September 9, 2011
Ref. No.: GR11-050

11V-467
(4 Pages)

RE: Part 573 Defect Information Report – Moonroof Glass Coming-off on 2011 Subaru Legacy & Outback Vehicles

Defect Information Report (49 CFR Part 573.6)

(1) Evaluation result of returned parts

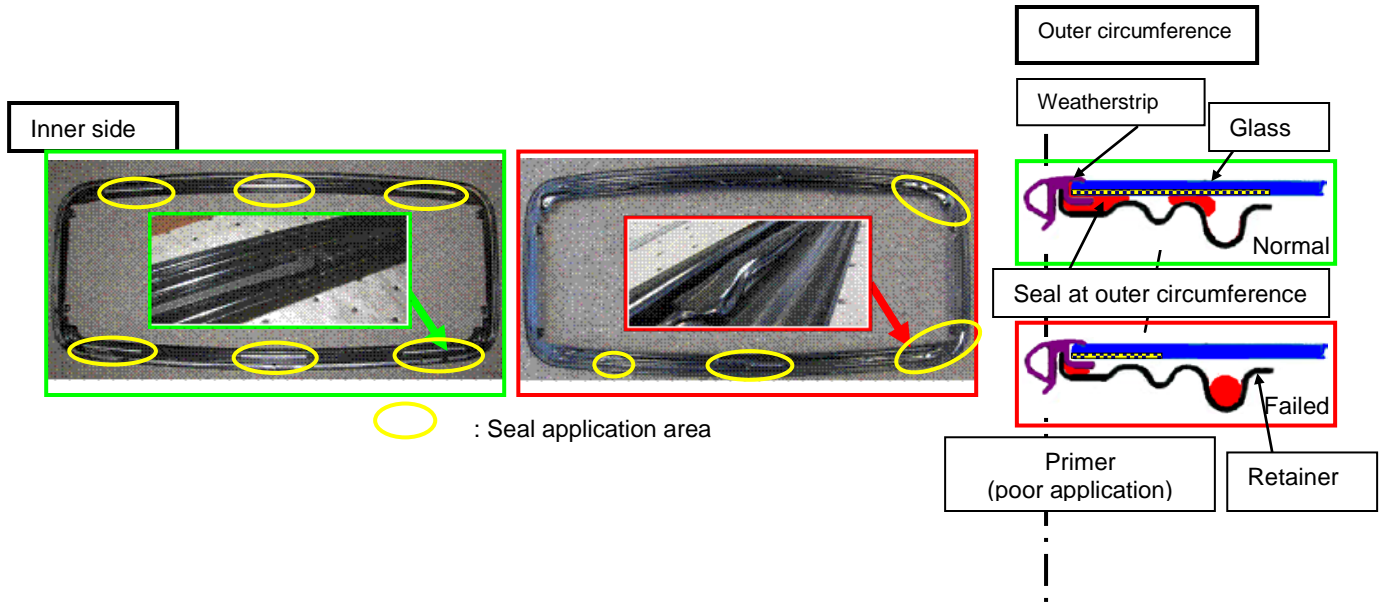
Moonroof glass comes loose or off. Adhesion area between glass and retainer is small.

- a) Width of primer application was found less than the amount specified in the design drawing in certain areas.
- b) Amount and positions of seal (adhesive) application was inappropriate at both of outer and inner circumferences of certain areas.
